===== LIGHT POLE PILASTER FOR APPROACH SLAB OR BRIDGE DECK THICKNESS LESS THAN 1'-5 1/2" AT COPING =====

2010 Interim Design Standard
LIGHT POLE PILASTER

Interim Date: 01/01/10
 Sheet No.: 1 of 3
 Index No.: 21200

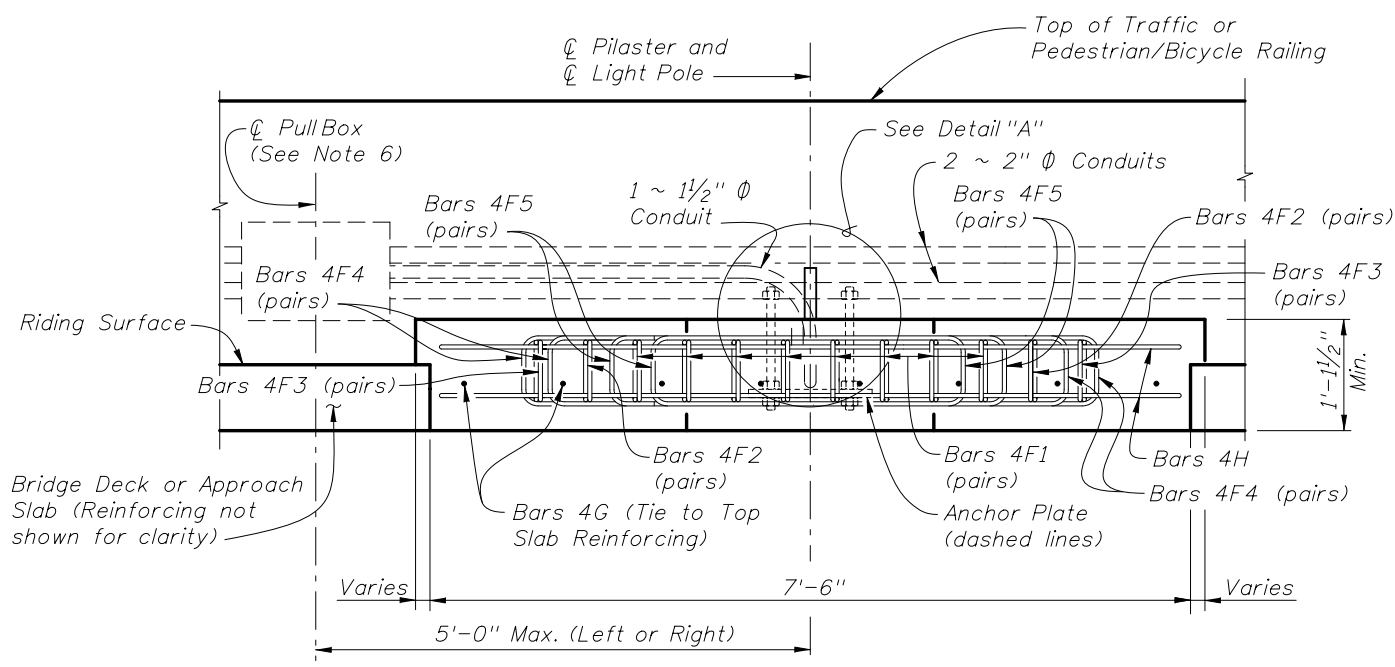
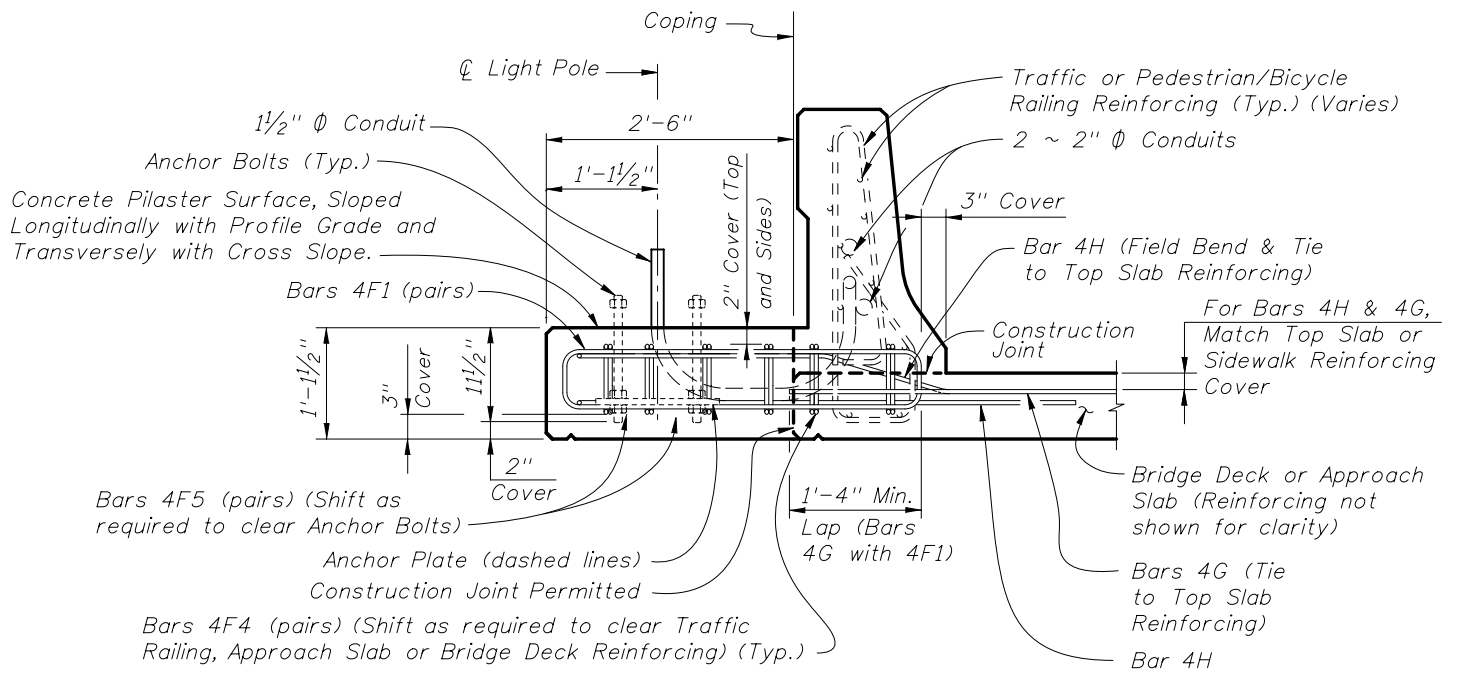
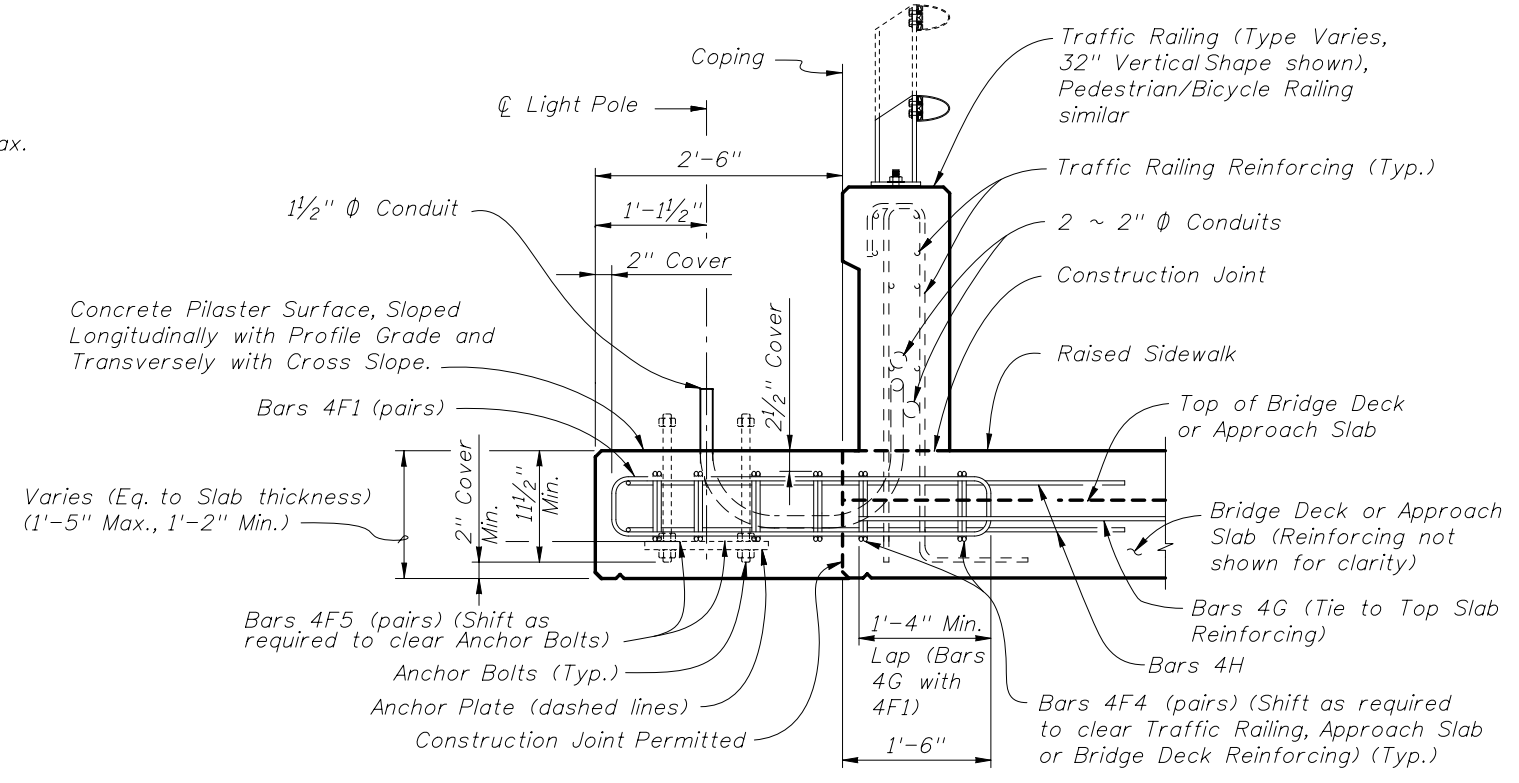
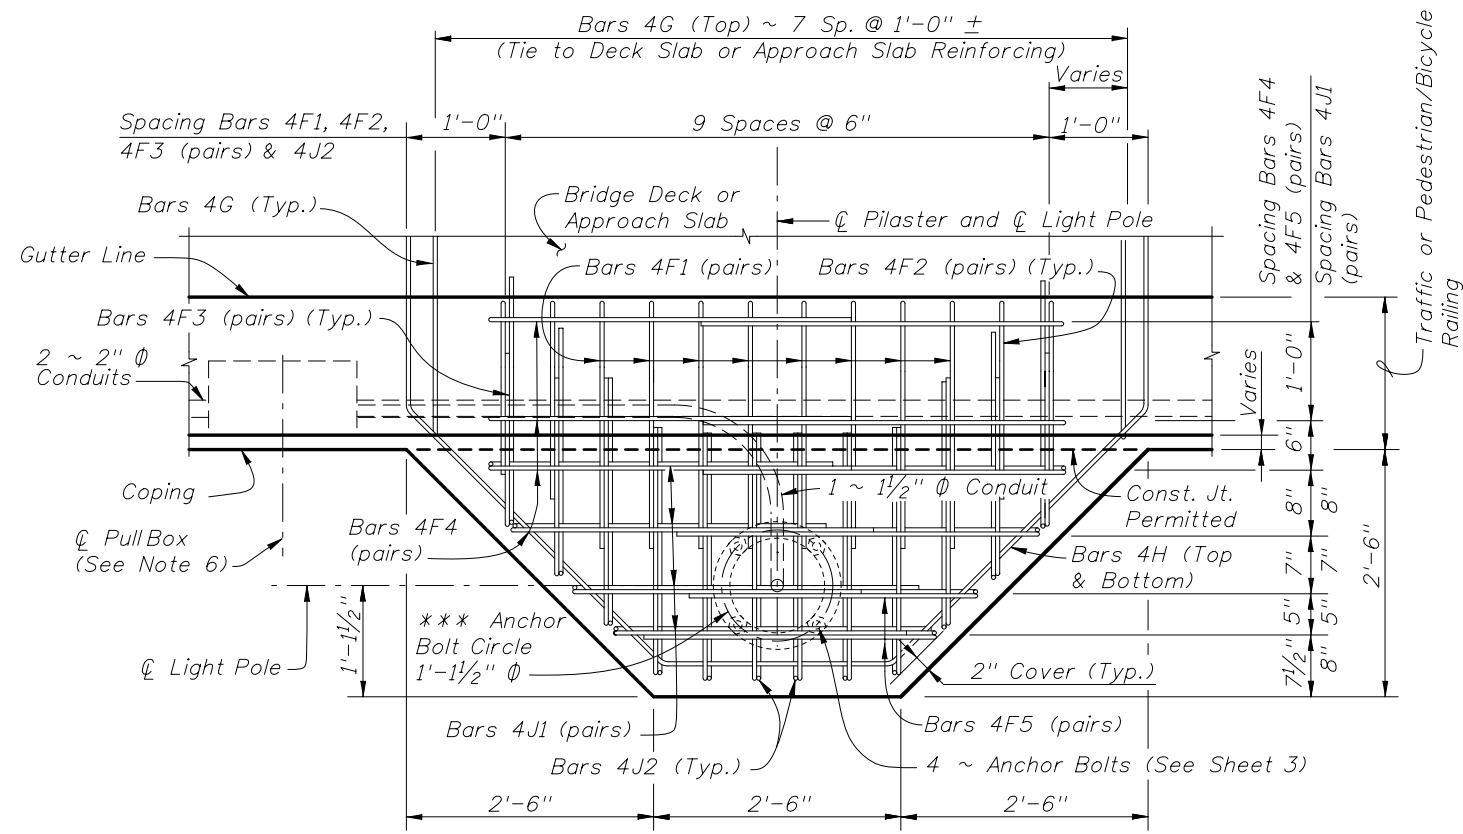
REVISIONS			
DATE	BY	DESCRIPTION	
01/01/10	SJN	Revised Typical Sections and "*" Slip Form Note. Deleted 1" Ø Weep Hole (PVC Conduit), Anchor Bolt size, 2 ~ Bars 4F4, and Bars 4G in bottom of deck slab. Changed spacing of Bars 4F. Added Lap Length for Bars 4G with 4F1.

Interim Date: 01/01/10
 Sheet No.: 3 of 3
 Index No.: 21200

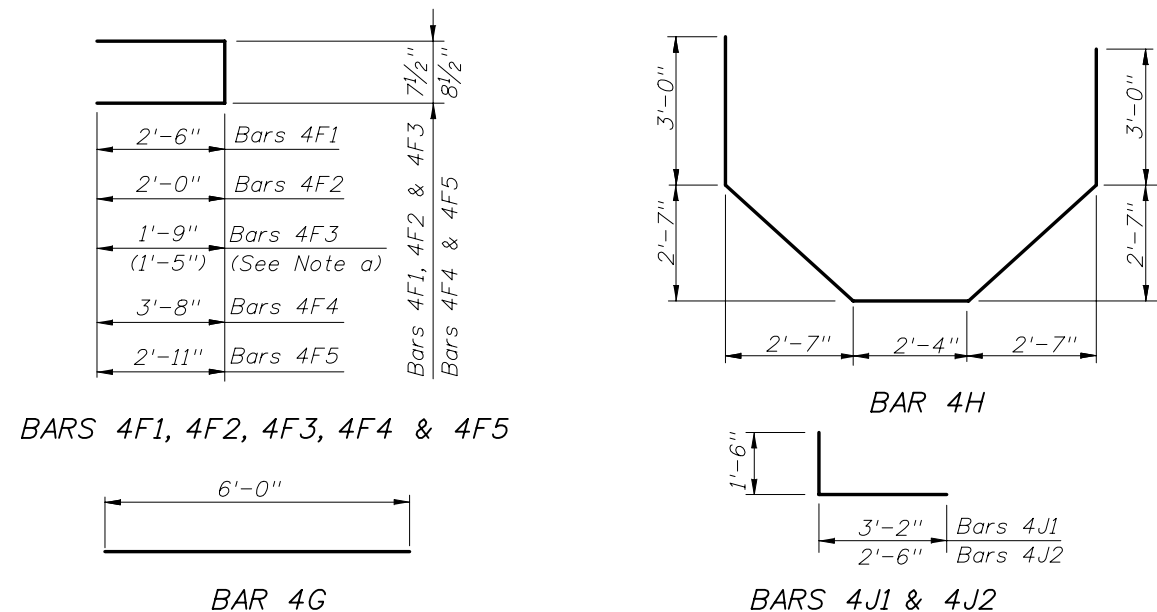
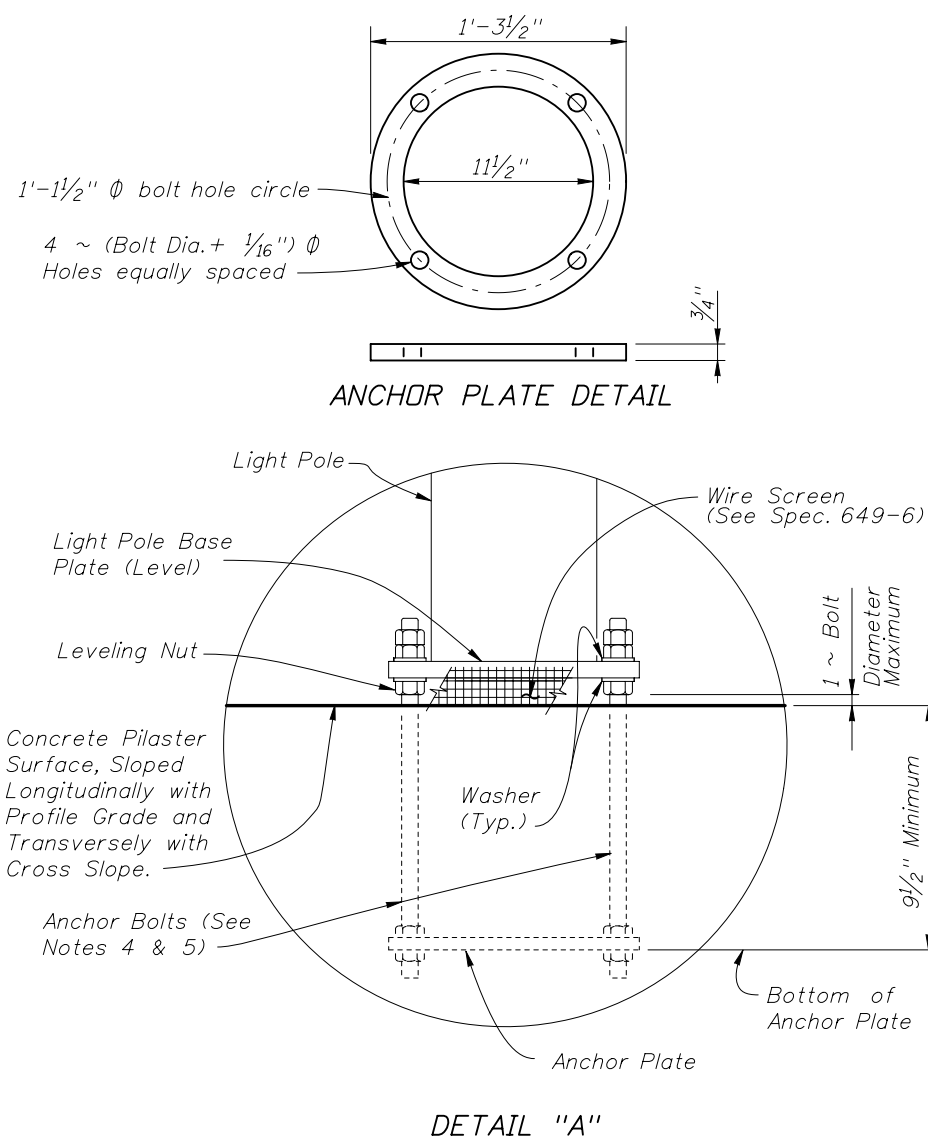
DATE	BY	DESCRIPTION	DATE	BY	DESCRIPTION
01/01/10	SJN	Deleted Grout Pad and 1" Φ Weep Hole in Detail "A". Changed No. of Bars 4H & 4F4, length of Bars 4F4 & 4F5, and Light Pole Pilaster Notes. Added Bars 4J1 & 4J2, Reinforcing Steel Note d, Wire Screen and Table 1.
